OJAI UNIFIED SCHOOL DISTRICT

BID ADDENDUM NO. 2 ISSUED 11/27/2019

REROOFING PROJECT AT NORDHOFF HIGH SCHOOL PROJECT NO. 2019-1713

ADDENDUM NO. 2

D-101

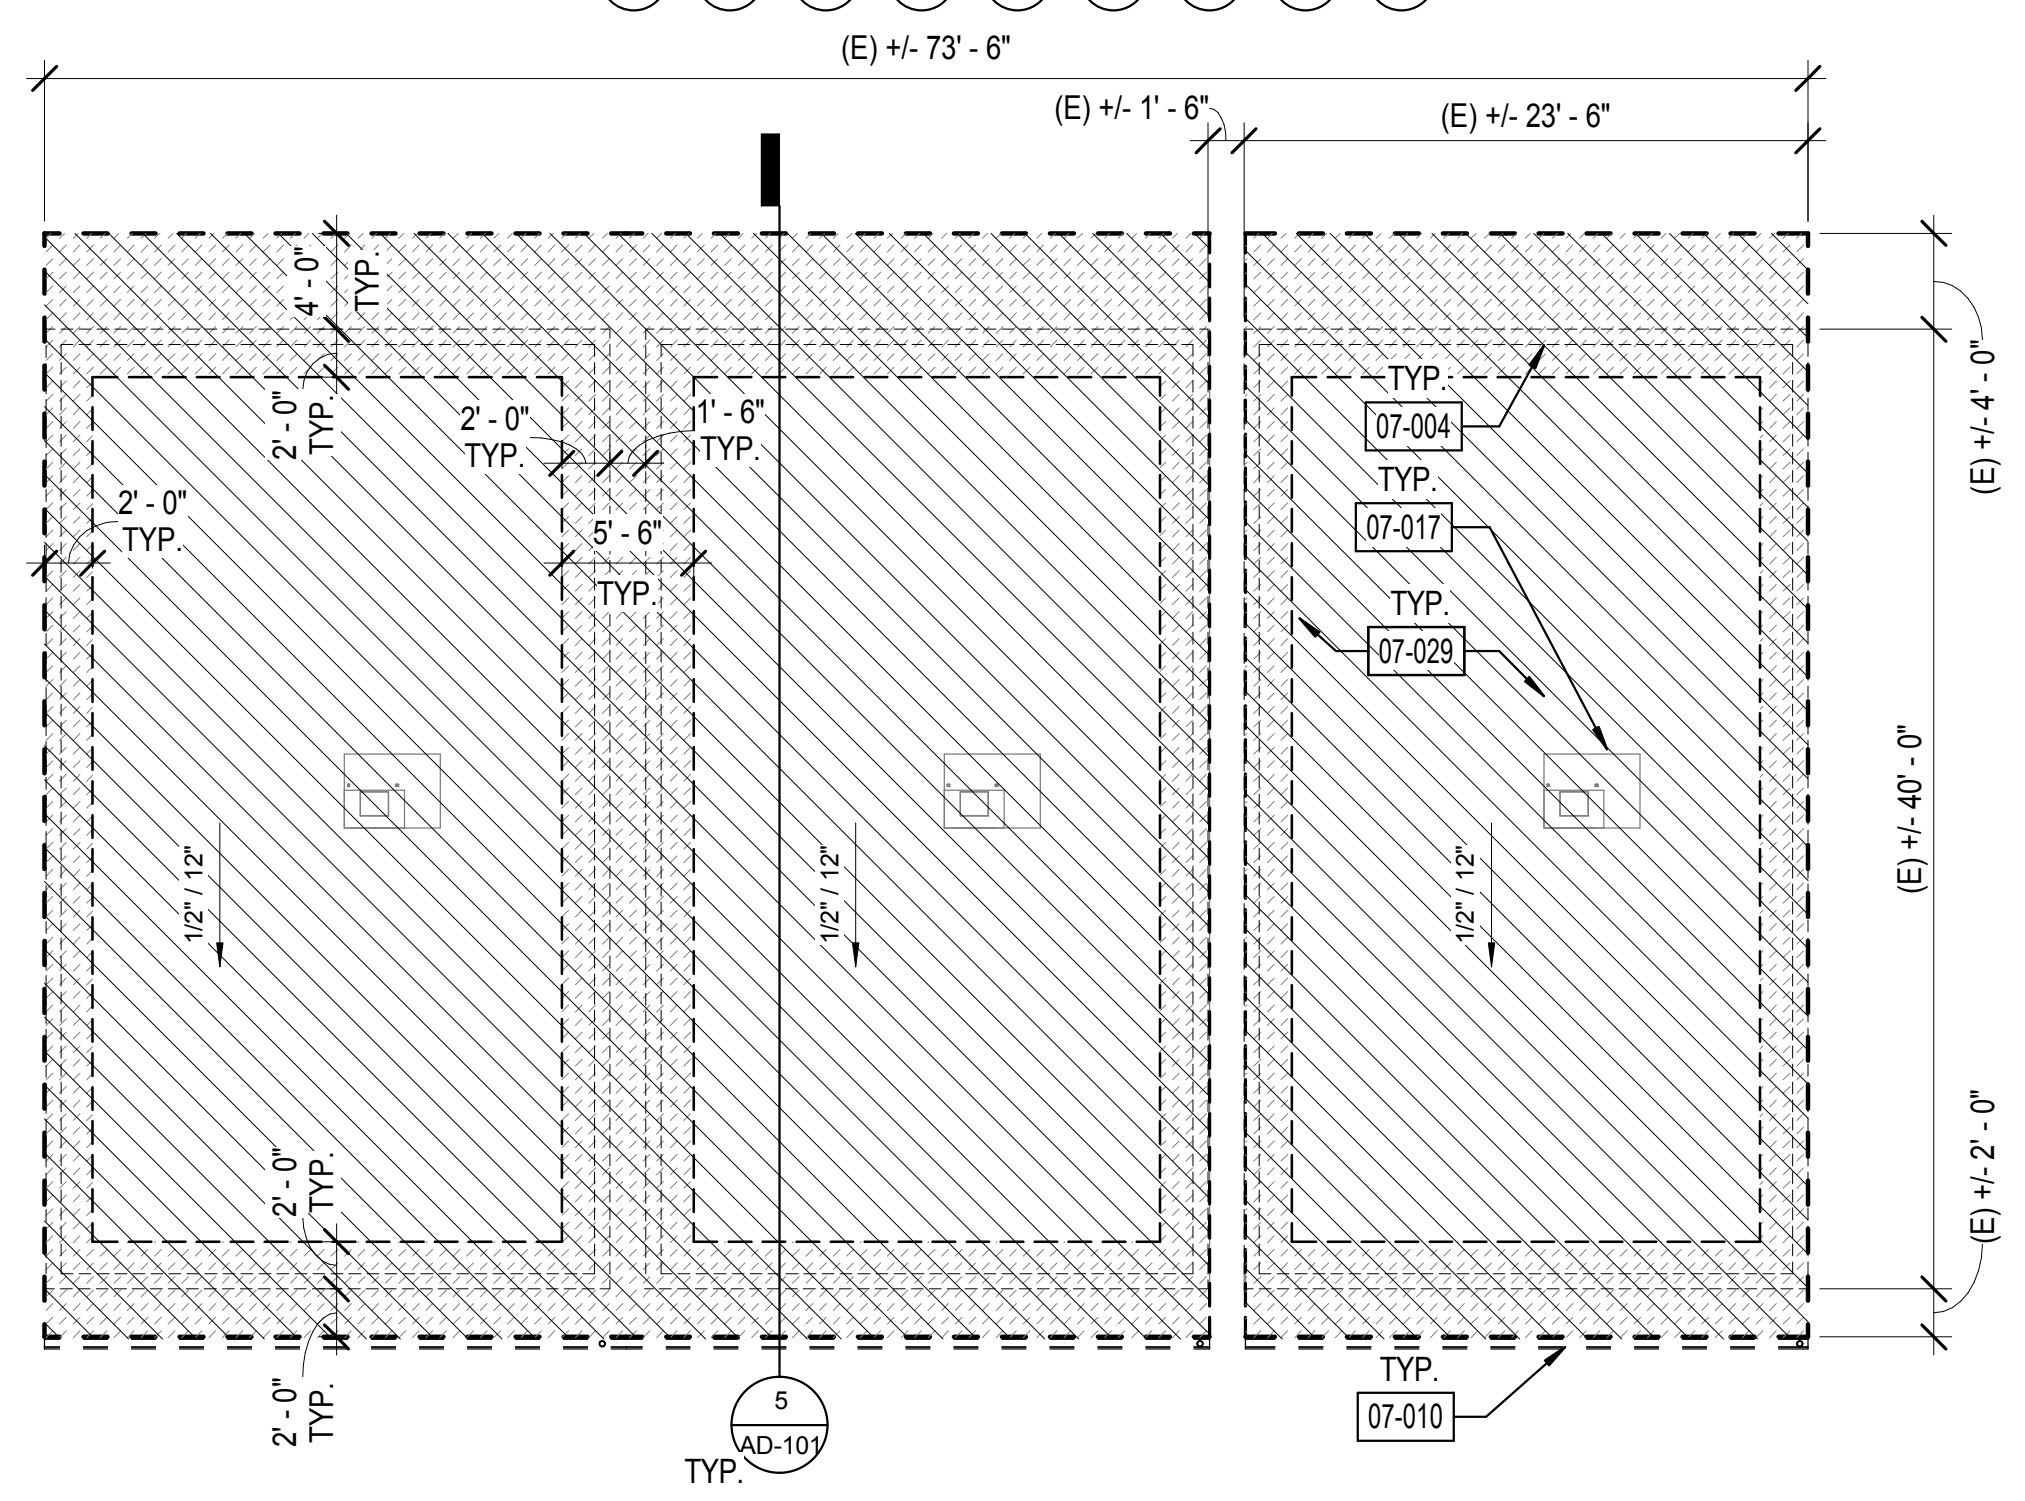
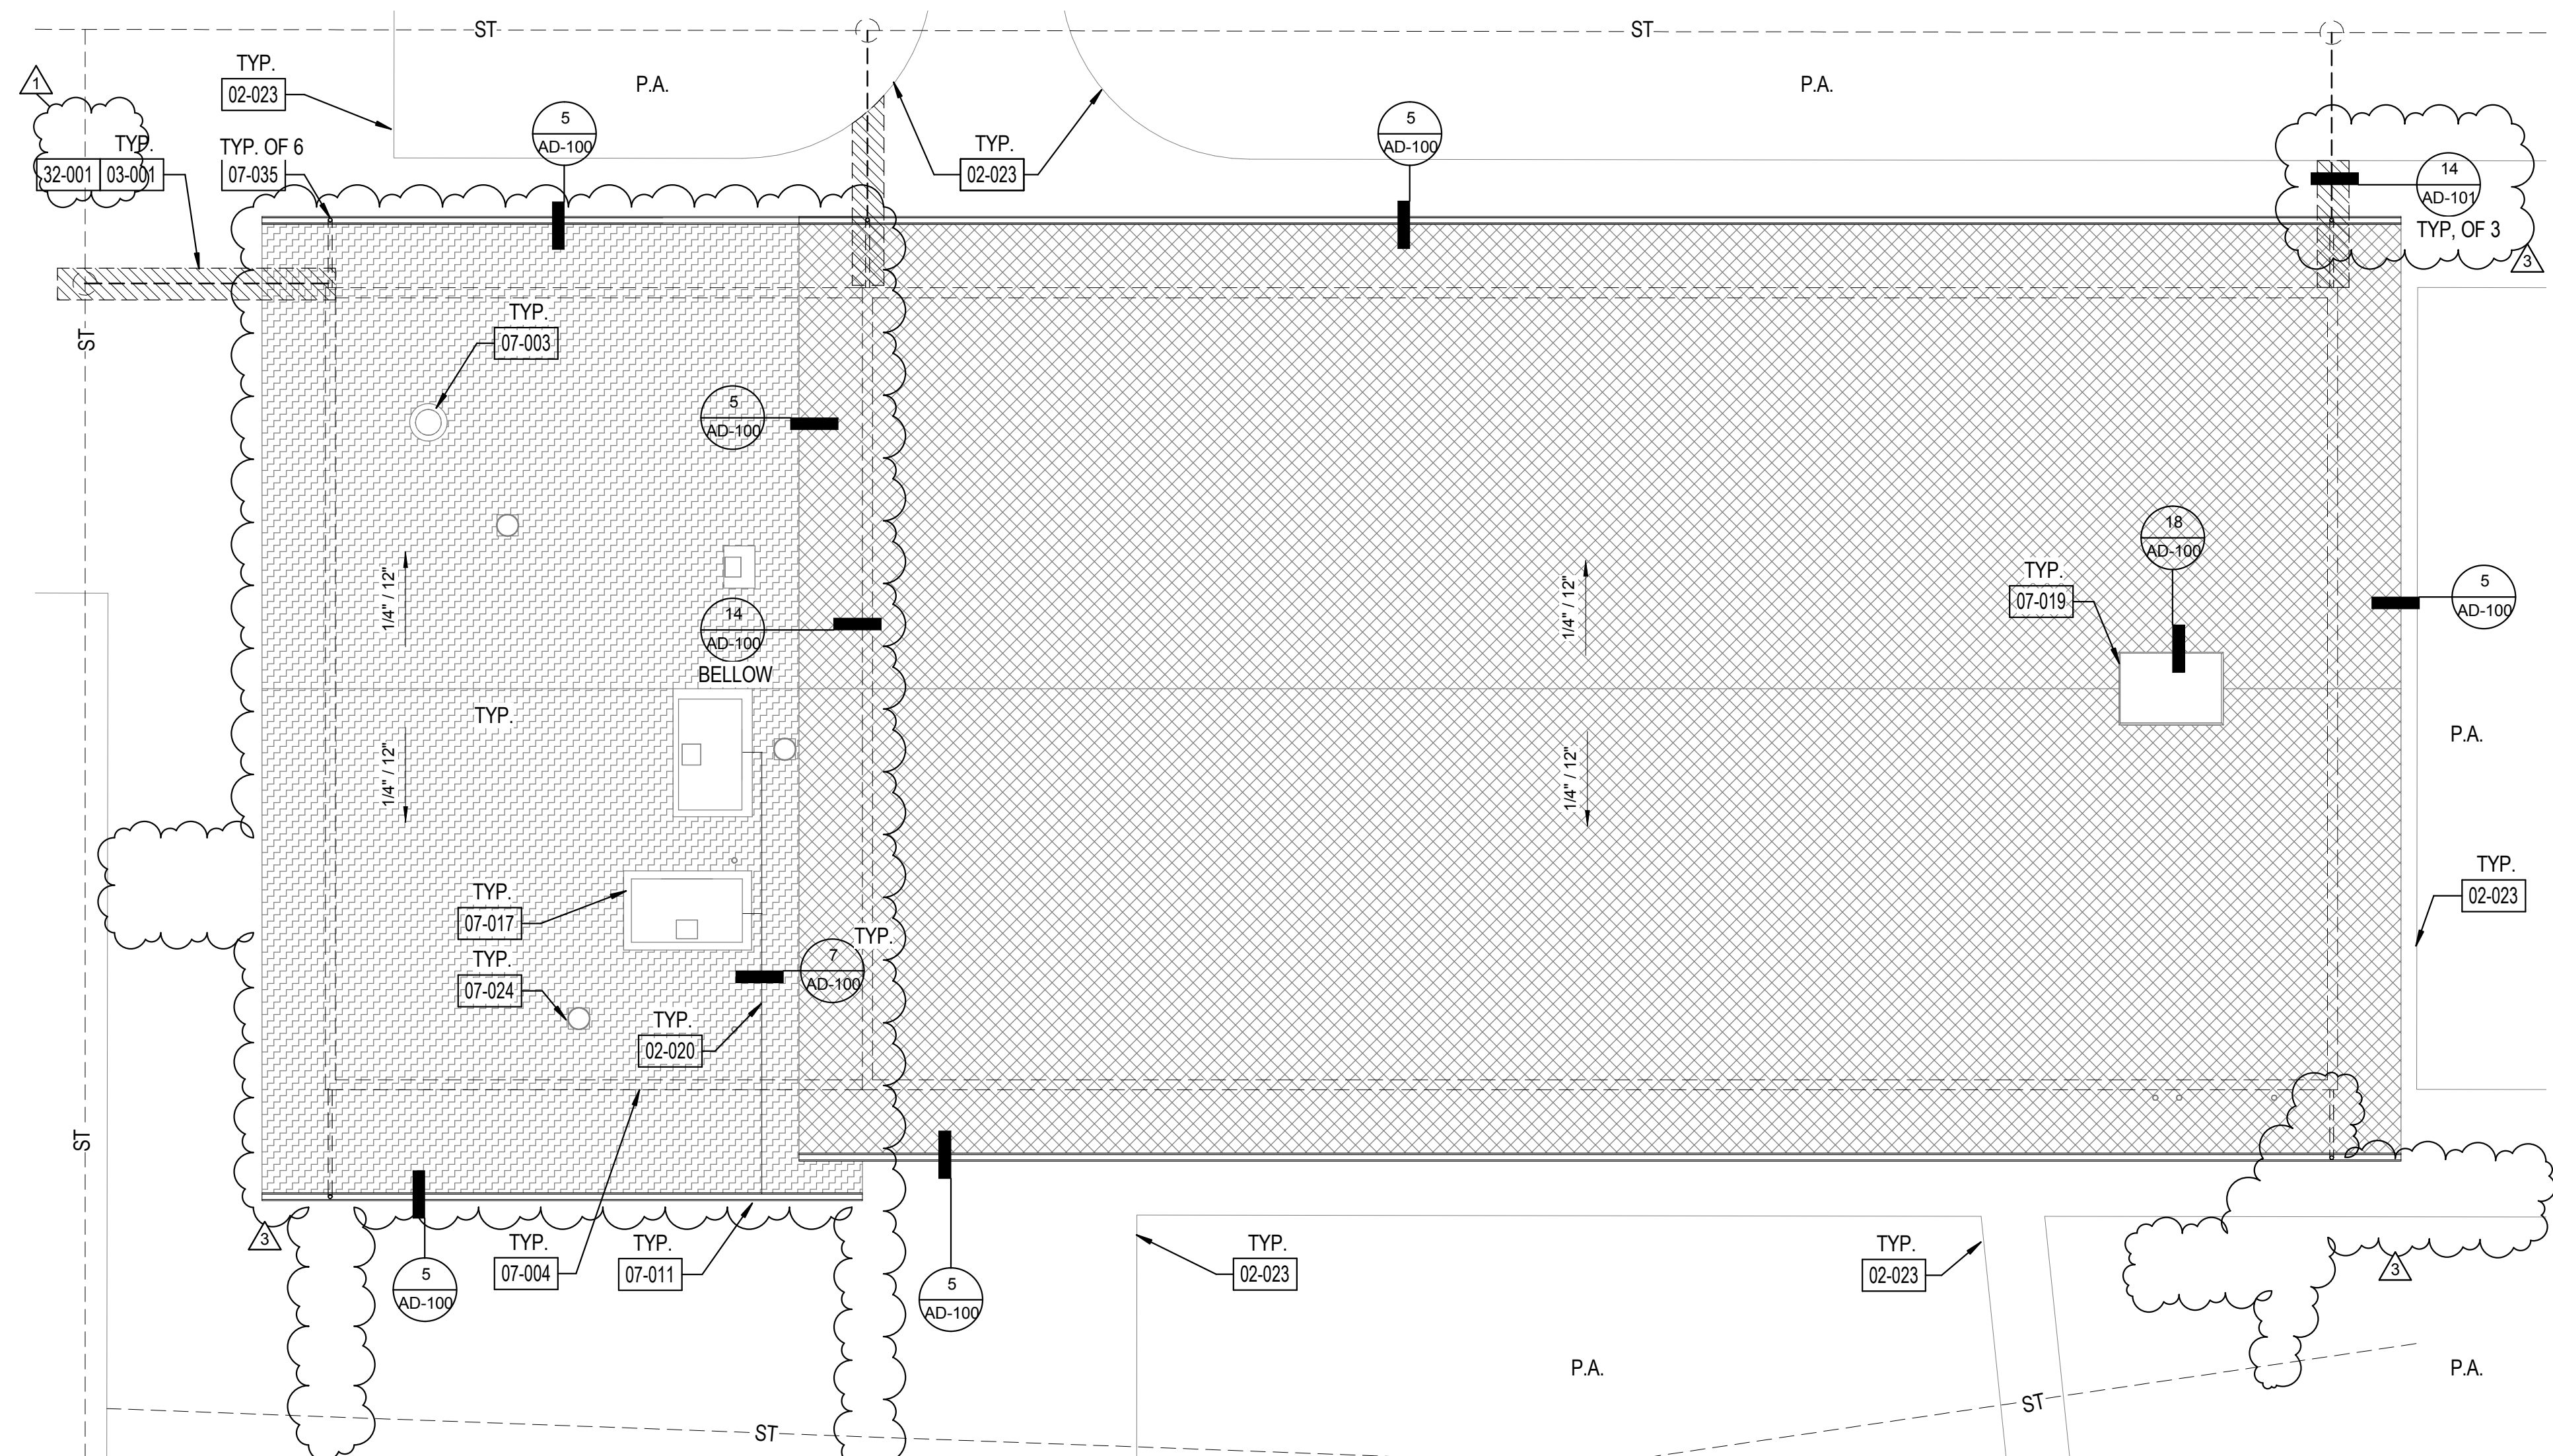
- Item 1. Drawings coordinated to show altered roof scope of Building I's lower which will be recoated and not replaced.
- o G-000 Title Sheet: Project Description Revised
 - o AS-100 Site Plan: Building I lower roof hatch revised.
 - o D-101 Building I & J – Roof Demolition Plans: Building I lower roof marked as recoating project and to remain and not be demolished.
 - o A-101 Building I & J – Roof Plans: Building I lower roof marked as recoating project. Callouts for roof details removed as required for coordination. Scope for connection of downspouts to underground storm drain line at south of cafeteria removed from this project as that work is already complete.
 - o 071326 Sec 3.4: A-1 Grit Arctic White or equal roofing granules to be embedded in White Star Roof Coating throughout all sections at 35 lbs. per 100 SF

- REMOVE AND REPLACE ROOF
- ASSUMED ROOF SHEATHING REPLACEMENT AT EAVES/ EDGES
- (E) EXHAUST FAN
- (E) VENT PIPE THROUGH ROOF
- (E) SKYLIGHT
- ROOF VENT
- (E) WALL BELOW
- DEMOLISH (E) ITEM
- PROTECT IN PLACE (E) ROOF, REFER TO A-101 FOR ADDITIONAL DETAILS ON COATING TREATMENT
